CITY OF FORT LAUDERDALE

DEVELOPMENT REVIEW COMMITTEE

CASE COMMENT REPORT

CASE:	UDP-S23069
MEETING DATE:	January 09, 2024
REQUEST:	Site Plan Level III Review: Conditional Use for Mixed Use Development with Allocation of 283 Multifamily Residential Units and 1,418 Square-Feet of Commercial Use
APPLICANT:	501 NE Holdings, L.P.
AGENT:	Andrew Schein, Lochrie & Chakas, P.A.
PROJECT NAME:	1000 Marina Mile Apartments
PROPERTY ADDRESS:	1000 W. State Road 84
ZONING DISTRICT:	Boulevard Business District (B-1)
LAND USE:	Commercial
COMMISSION DISTRICT:	4 – Warren Sturman
NEIGHBORHOOD ASSOCIATION:	Edgewood Civic Association
CASE PLANNER:	Michael Ferrera

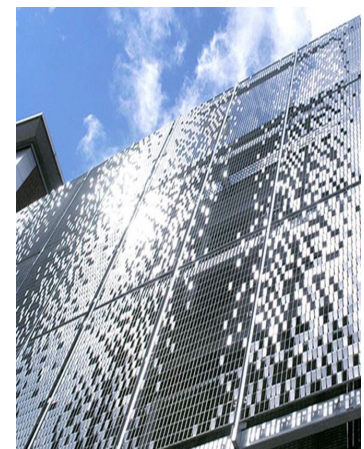
18. Pursuant to Section 47-23.9, Interdistrict Corridor Requirements for State Road 84 frontage, as proposed the project does not meet this section and the following need to be addressed:

- a. *Build-to line.* A minimum of seventy-five percent (75%) of the linear frontage of a development site along State Road 84 shall be occupied by a ground floor building wall located twenty (20) feet from the curb line. Clearly delineate how this is being met.

- b. *First floor transparency.* A minimum of thirty-five percent (35%) of the first-floor facade of a building facing State Road 84 shall utilize transparent elements such as windows, doors and other fenestration.

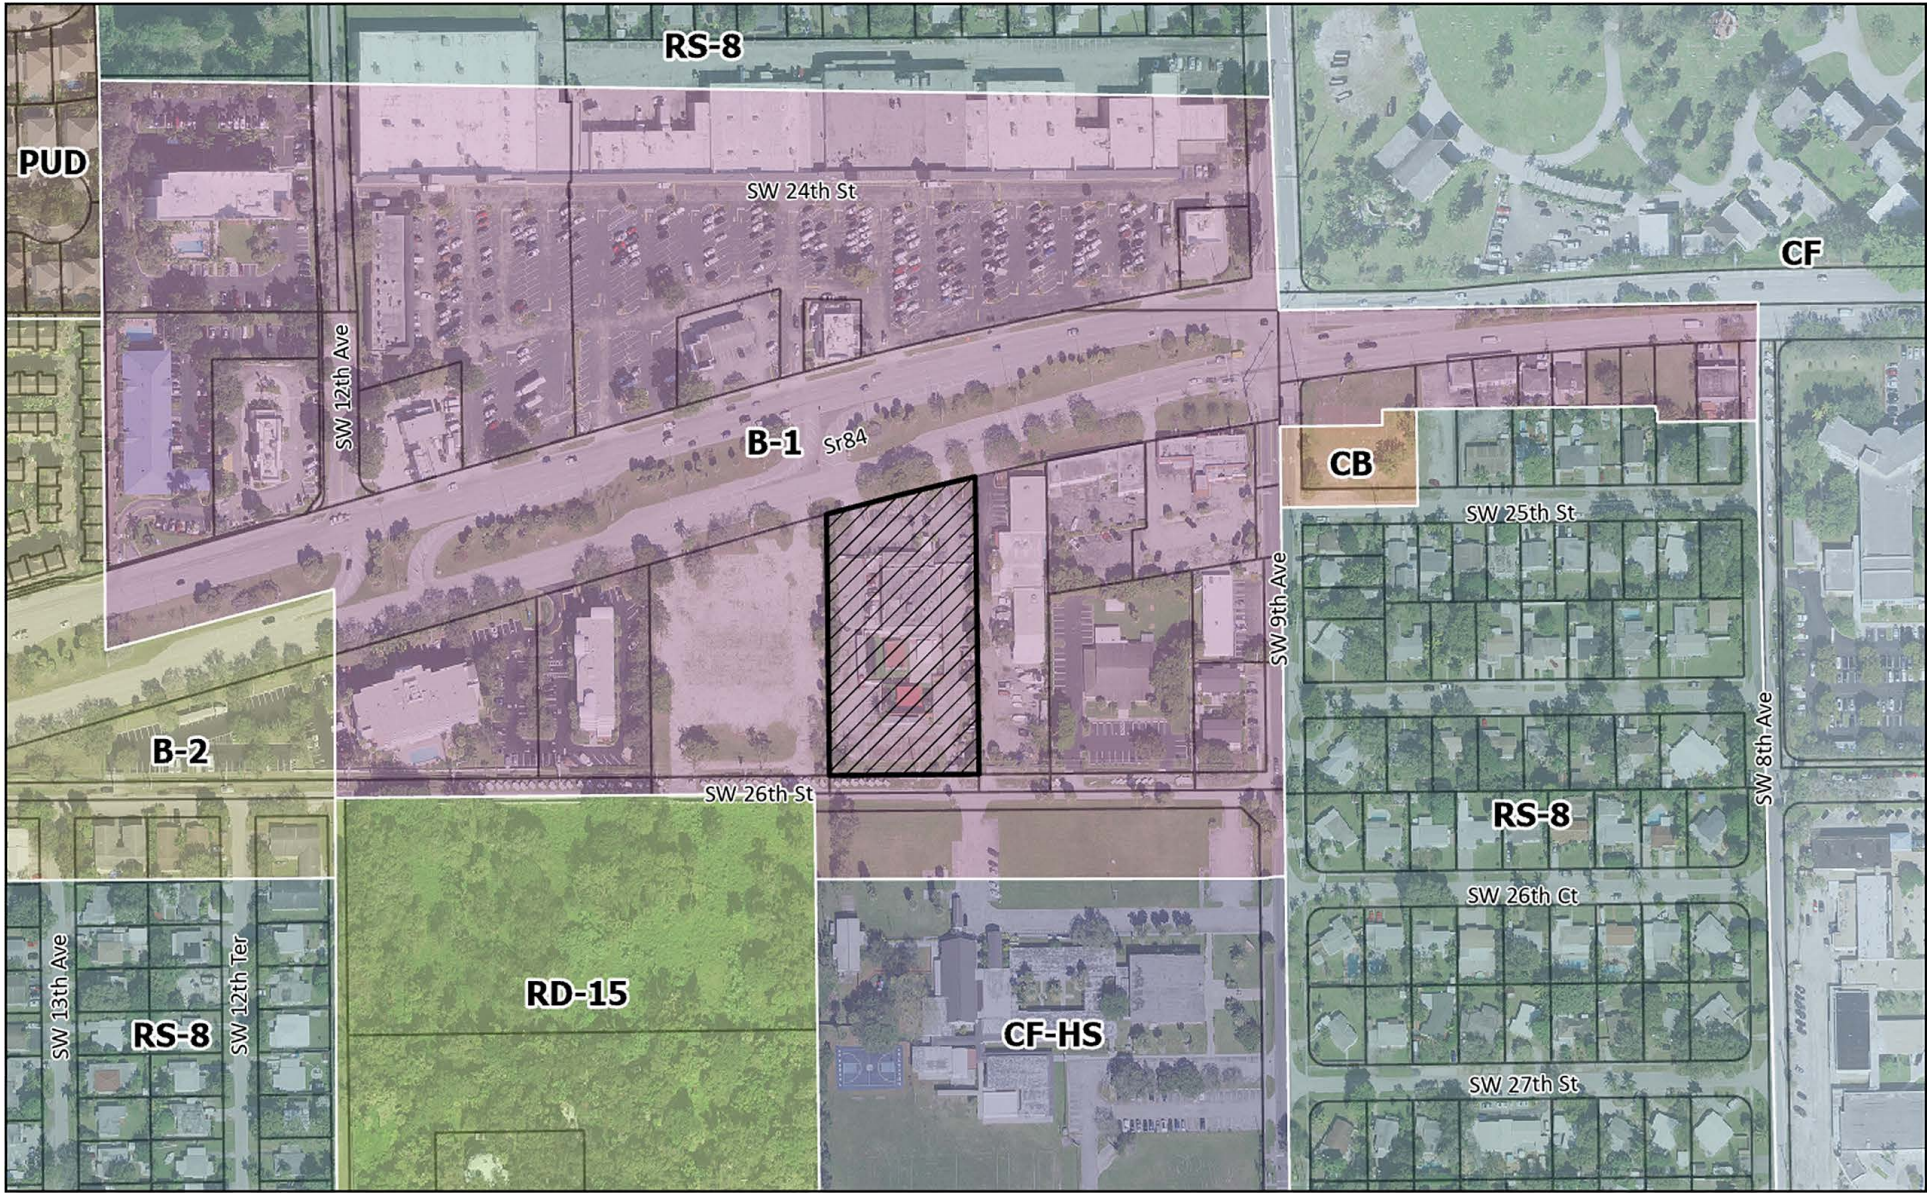
25. The garage screening on the east façade proposes an architectural louvered screening, which does not provide sufficient screening. Exceptional screening solutions should be used that provide variation in form and material given the large surface areas of the parking garage façades. Ensure screening adequately blocks out light and noise pollution. See below for examples of screening materials.
